PROJECT: Summiton West V22 - Kestrel Creek Avenue (Street 1)

CITY OF LAS VEGAS		DATE:
INTER-OFFICE MEMORANDUM		December 2, 2019
TO: Land Development Services Department of Building & Safety		FROM: Albert Sung, P.E. Flood Control Project Engineer Department of Public Works
SUBJECT:	COPIES TO:	
Drainage Study for:	Atkins	
Summerlin West V22 – Kestrel Creek Avenue (Street I) (from Desert Foothills Drive to Kettle Ridge Drive <Street J>)		
Cross Streets:	Desert Foothill Drive & Kestrel Creek Ave.	Howard Hughes Company, LLC
File Number:	F:\Depot\DSMemos\DS5171C.doc	Bart Anderson, P.E., DevCo
Parcel Number:	137-14-401-006 & 137-23-101-002	
Zoning Action:	N/A	
FEMA Flood Zone	YES	NO X
Proposed Storm Drain	YES X	NO

Kestrel Creek Avenue (Street I): Desert Foothills
Drive to Kettle Ridge Drive (Street J)
Technical Drainage Study

Supplement #1 to Addendum #1

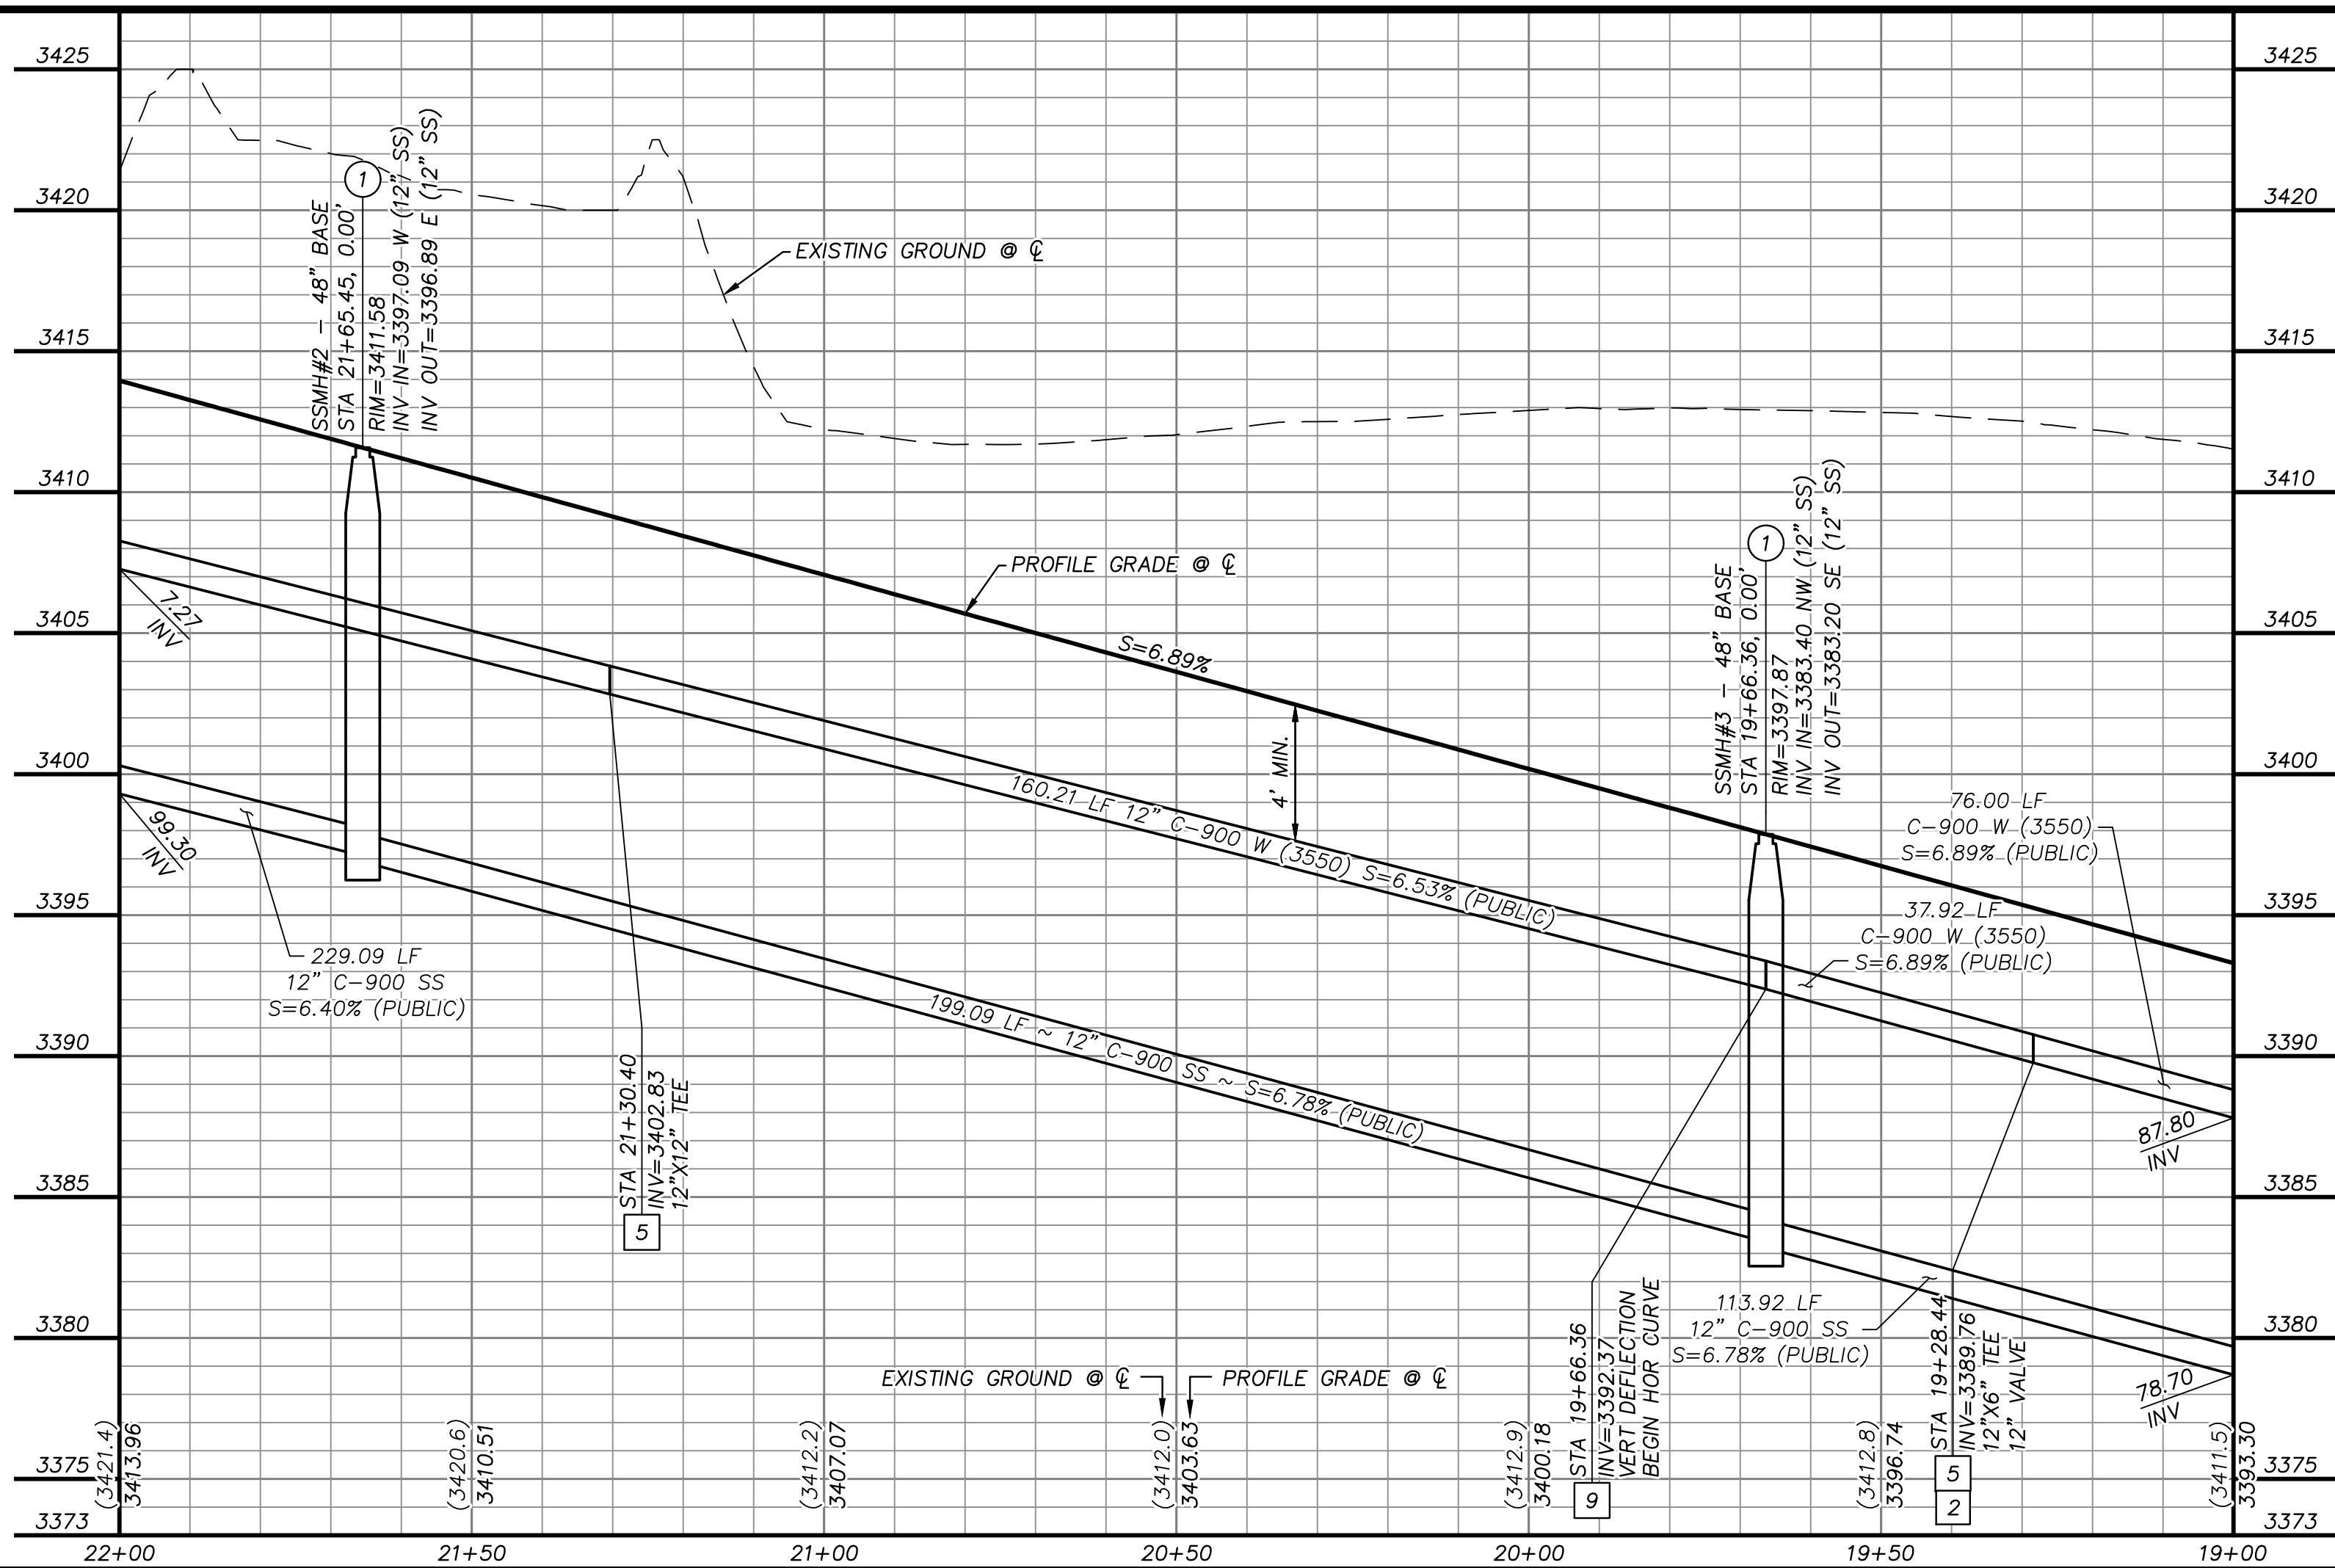
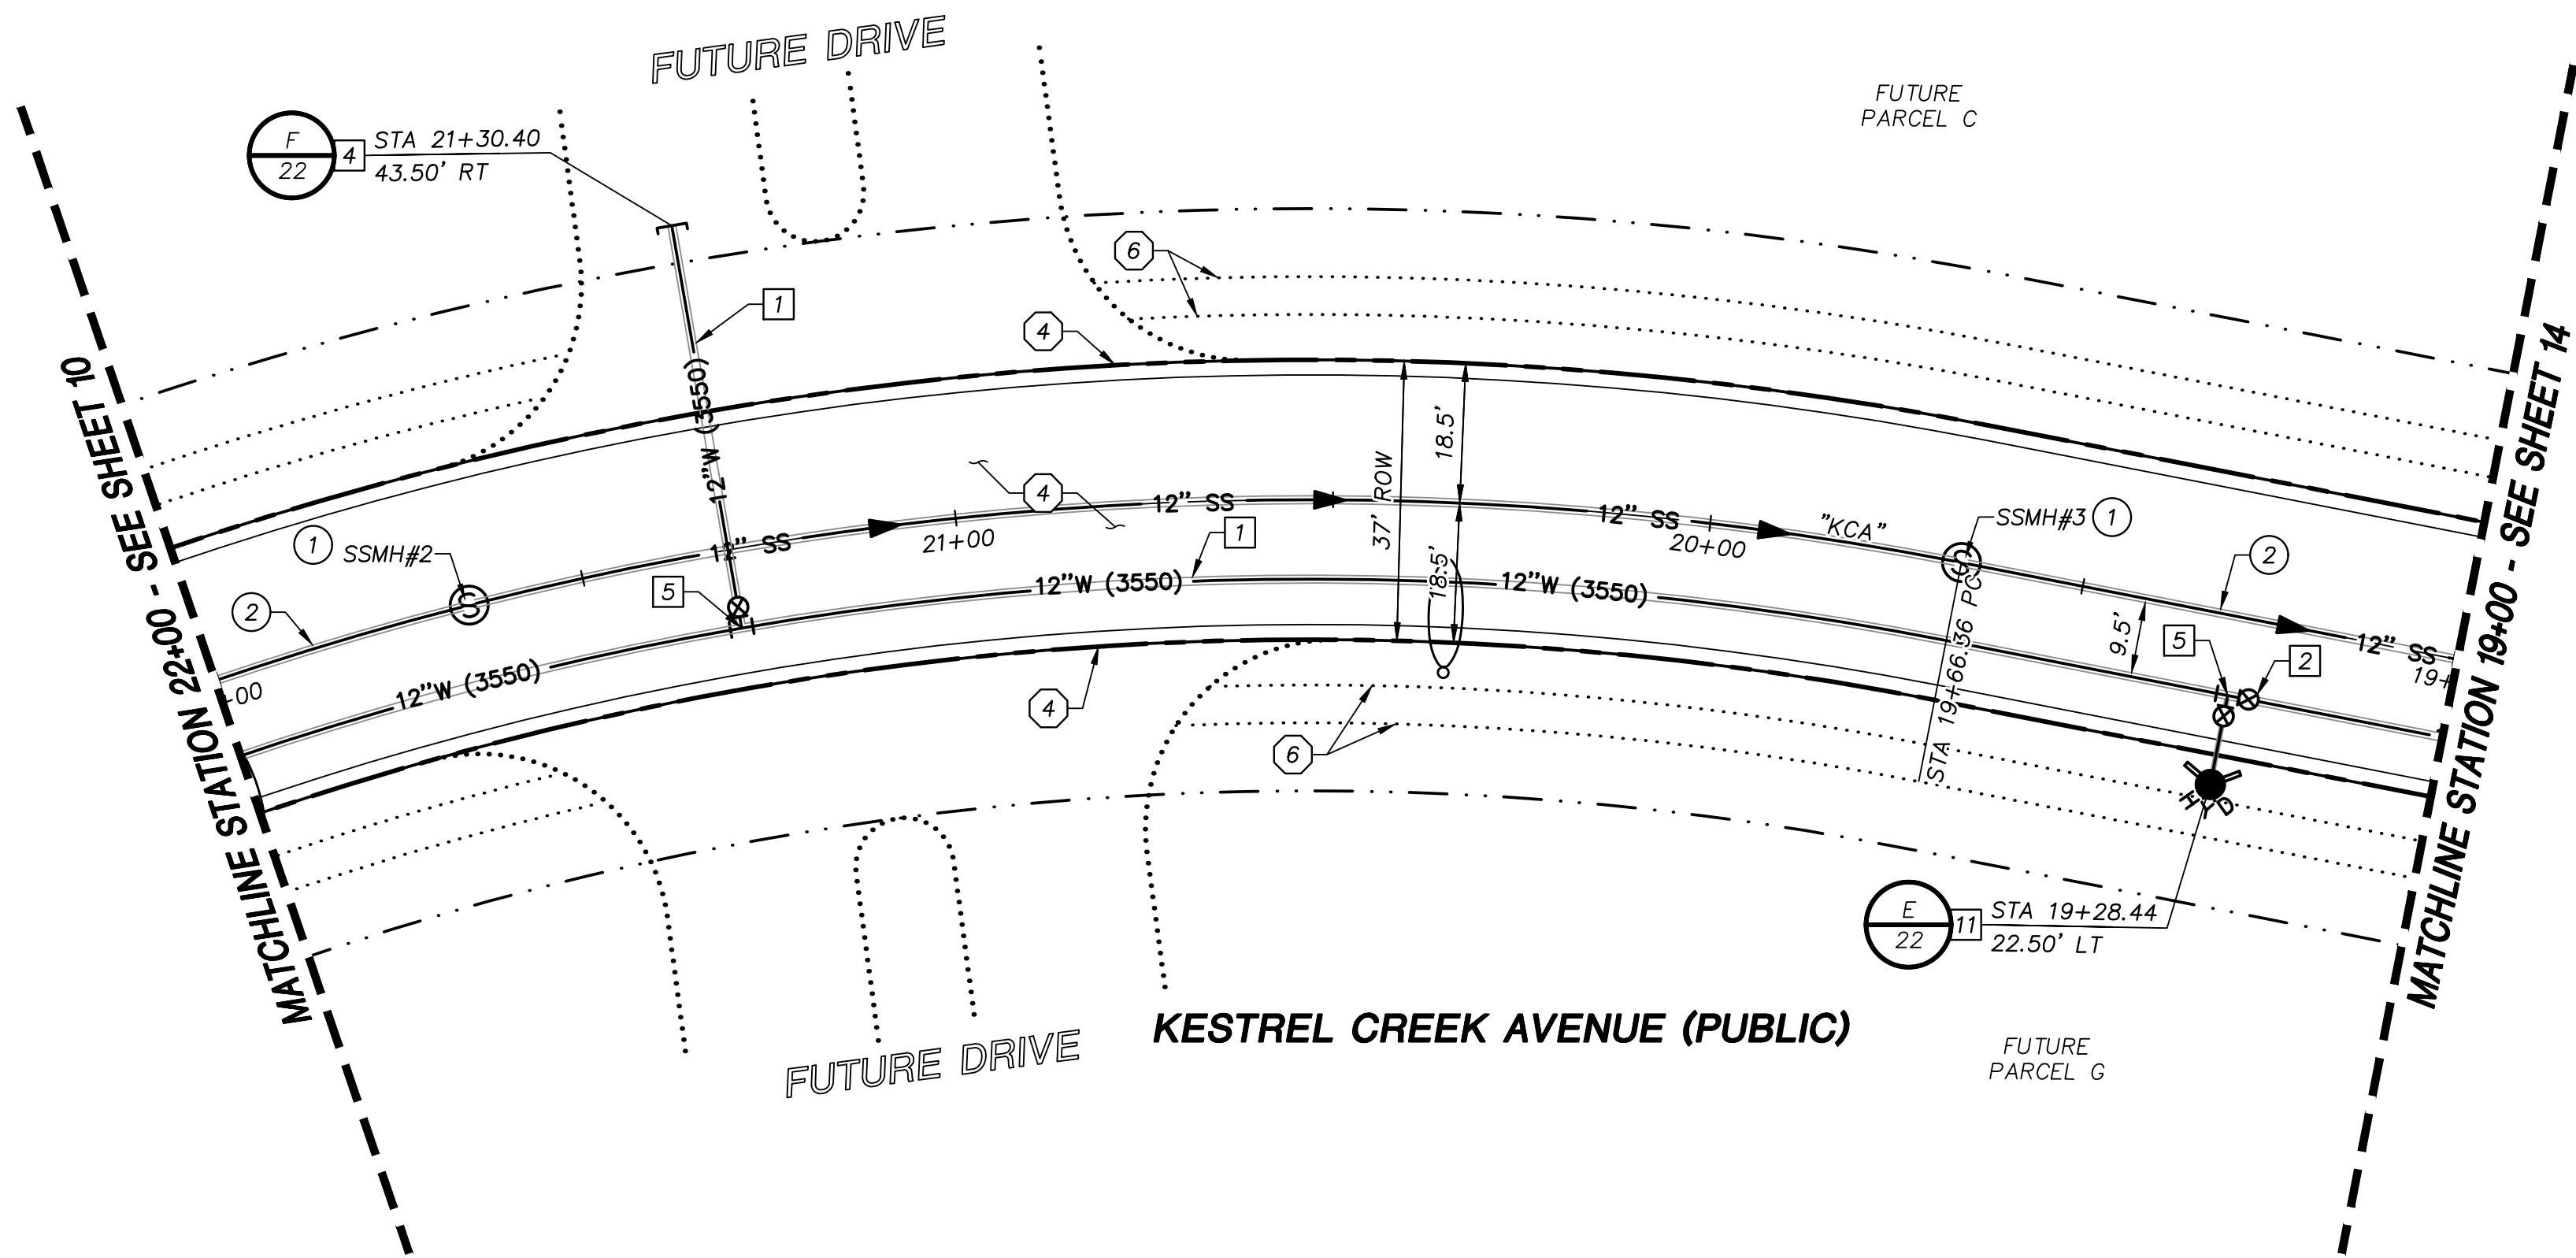
Comment #3: Sheet 9/27: A comment was issued for the *Kettle Ridge Drive Improvements Drainage Study* to relocate the regional storm drain towards the street center as much as possible. However, the subject improvement plan still shows that the regional facility under the curb & gutter of *Kettle Ridge*. Review and revise accordingly.

3. **Sheet 9/27:** A comment was issued for the *Kettle Ridge Drive Improvements Drainage Study* to relocate the regional storm drain towards the street center as much as possible. However, the subject improvement plan still shows that the regional facility under the curb & gutter of *Kettle Ridge*. Review and revise accordingly.

Comment response: The storm drain within the Kettle Ridge Drive Improvements Drainage Study has relocated the regional storm drain towards the center of the street as much as possible and has been revised accordingly in this study.
